Service Bulletin

Model: D-321

No. 368

Subject: During Battery power, When Battery's Voltage
Drops To A Low Level, Noise Is Heard

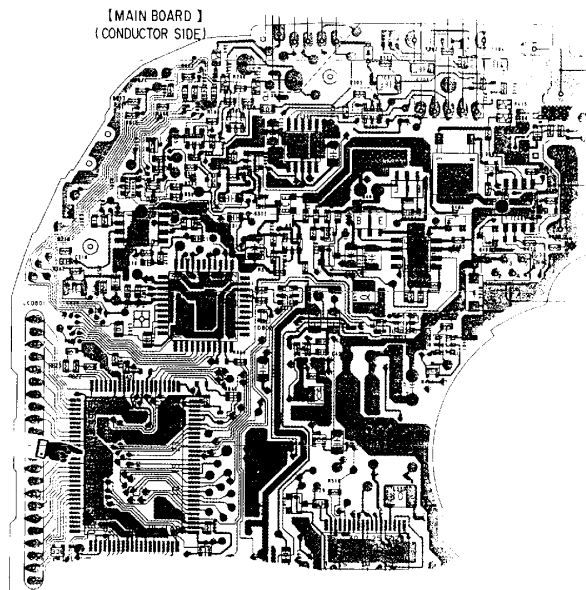
Symptom:
(57)

During battery power, when battery's voltage drops to a low level, noise is heard

Solution: replace IC801 to the part listed below.

REF	DESCRIPTION	PART NUMBER
IC801	IC CXP83916-610Q	8-752-851-84
